BRITISH GLIDING ASSOCIATION

TECHNICAL COMMITTEE

TNS 11/12/80

301-41-4/2

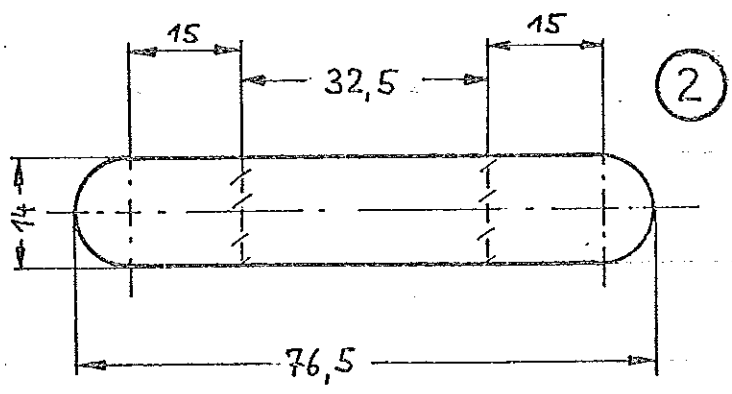
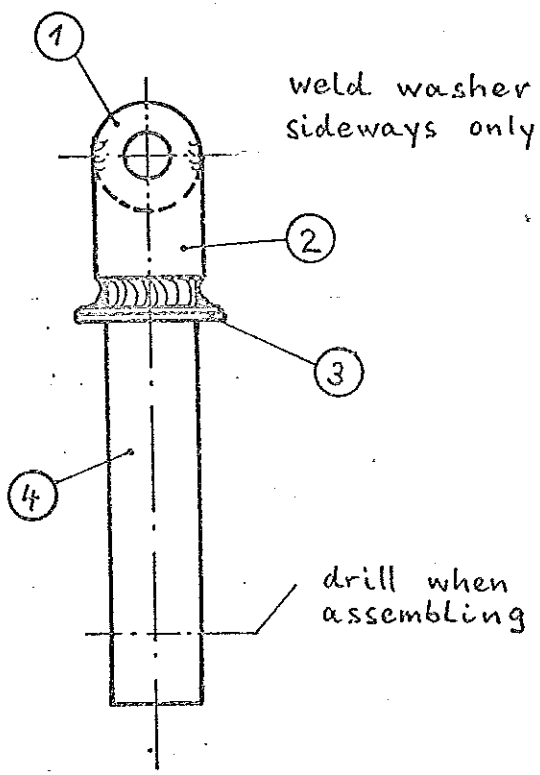
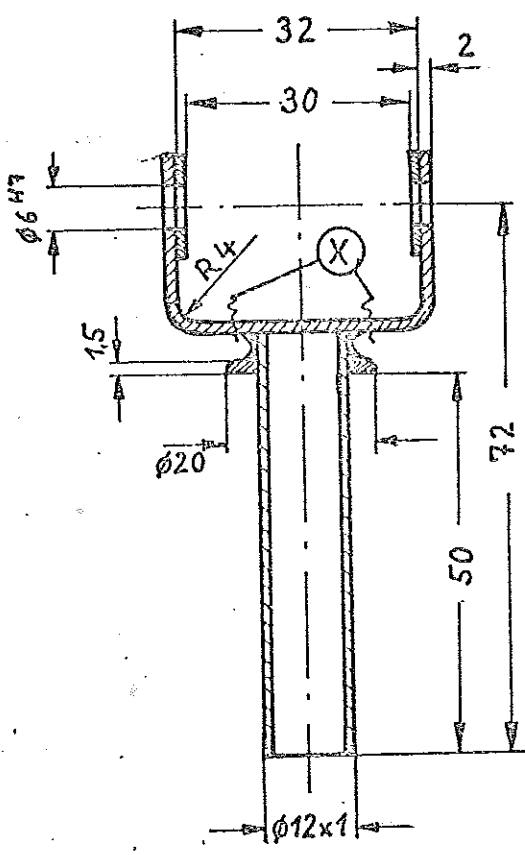
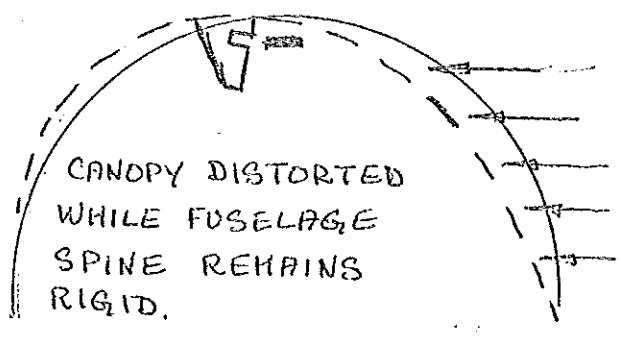
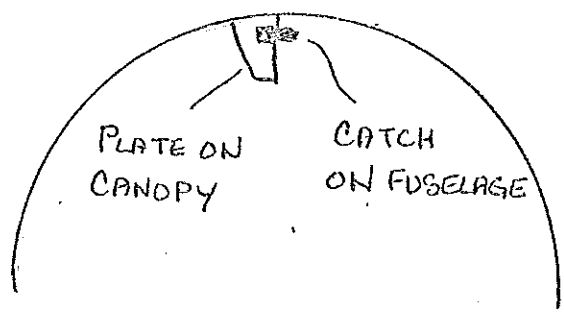
Action 1: The Elevator Linkage at the base of the stick (see modified drawing No. 301-41-4/2) must be inspected carefully by means of a magnifying glass (magnification at least 5x) for possible cracks near the welded seam. This inspection must be made immediately and again following the application of high loads to the glider (e.g. hard landing or ground loops). If cracks are found the glider must not be flown until the defective part has been replaced.

Action 2: The Elevator Linkage at the base of the stick must be replaced by a modified part in accordance with drawing No. 301-41-4/2 Replacement must in all cases be effected until November 1st 1980.

(X) Position of possible cracks on original Elevator Linkage

- ① washer (2x) St $\varnothing 14 \times \varnothing 5,5 \times 1$
- ② frame 1.7734.4 $76,5 \times 14 \times 2$
- ③ washer St $\varnothing 20 \times \varnothing 12 \times 1,5$
- ④ tube 1.7734.4 $\varnothing 12 \times 1 \times 56$

heat-treatment after welding: Tempering in controlled atmosphere
1 hour at 550°C

BGA/VTC CIRBUS/11/80.

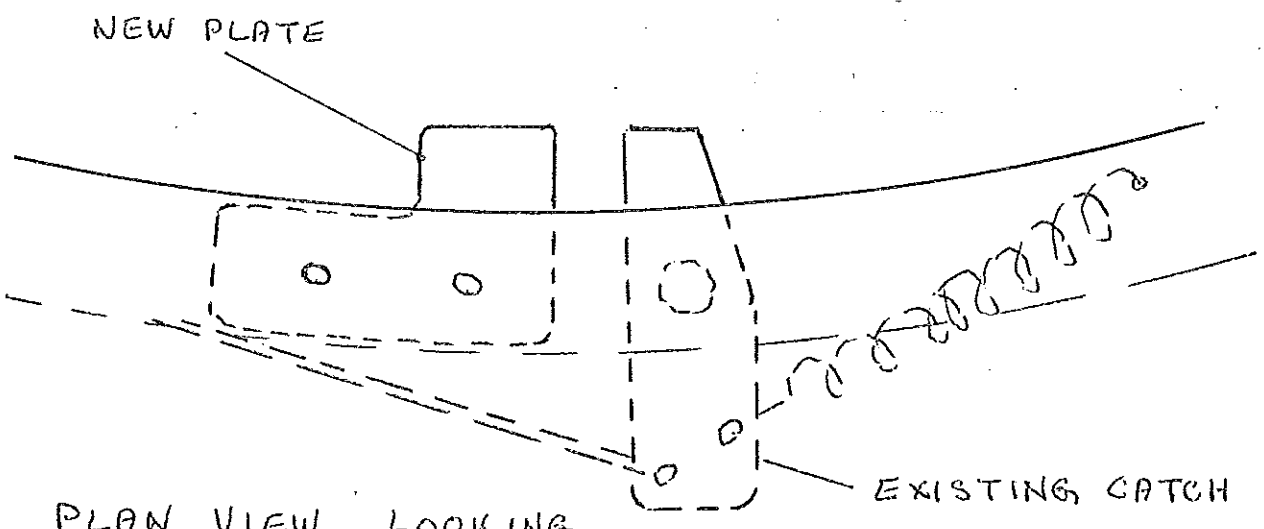
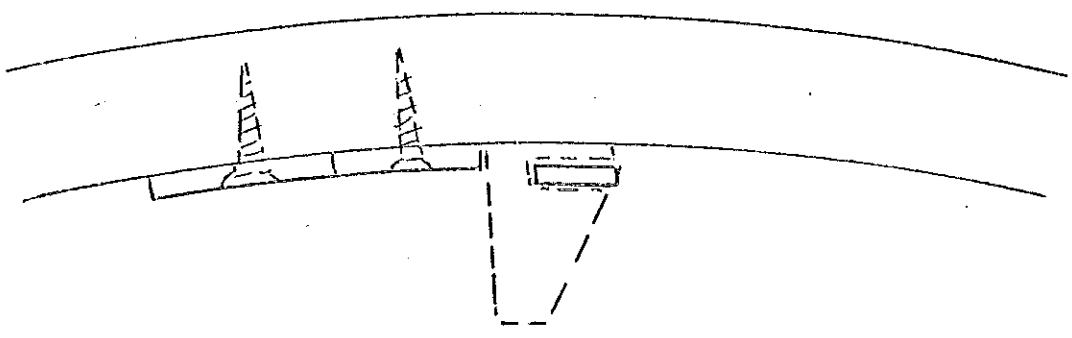
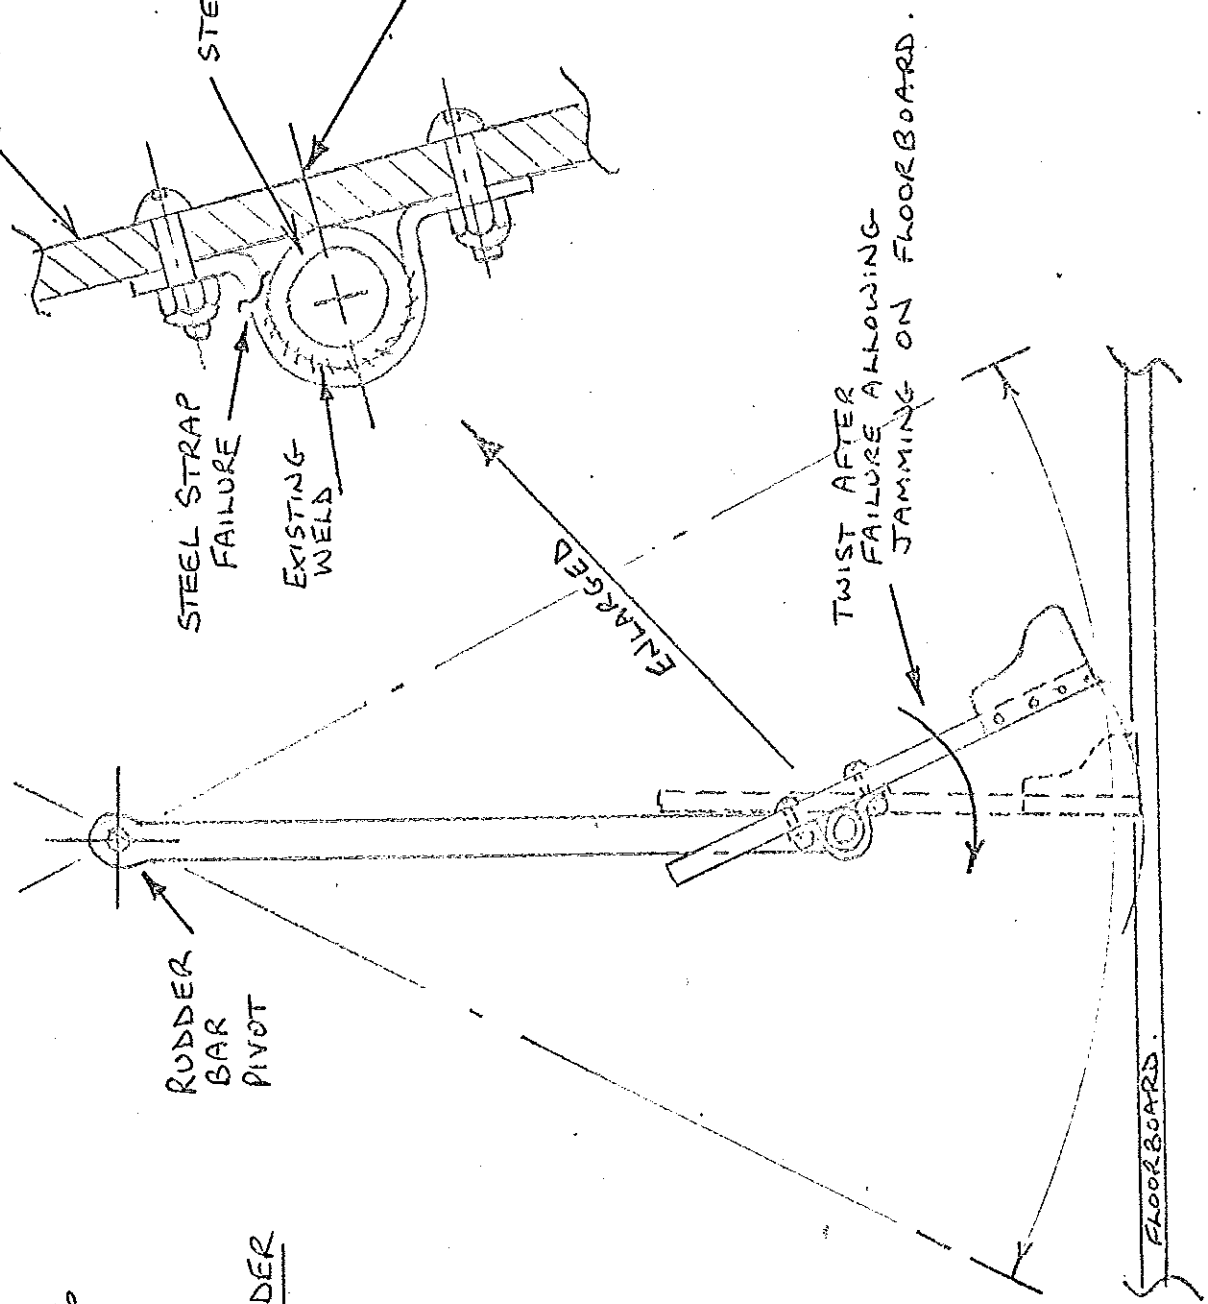
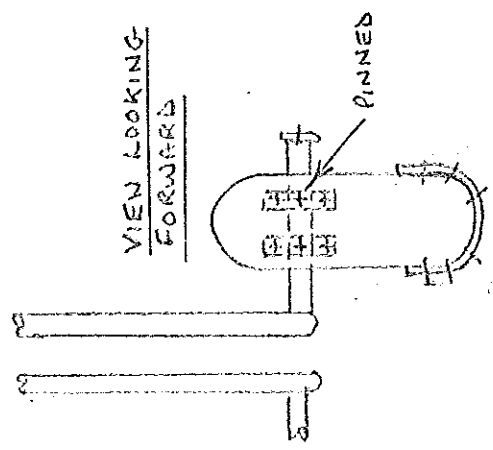
SUGGESTED CAUSE OF CANOPY DISENGAGEMENT
VTC CIRBUS.

VIEWS ON REAR ARCH OF CANOPY LOOKING FORWARD

DIAGRAM SHOWING PLATE ADDED TO BGA 1835

VIEW LOOKING FORWARD SHOWING PLATE ON CANOPY PREVENTED FROM MOVING Laterally, PLATE MATERIAL 12SWG, L72 AS THAT WAS READILY AVAILABLE. WILL BE CHANGED TO STEEL IF IT WEARS.
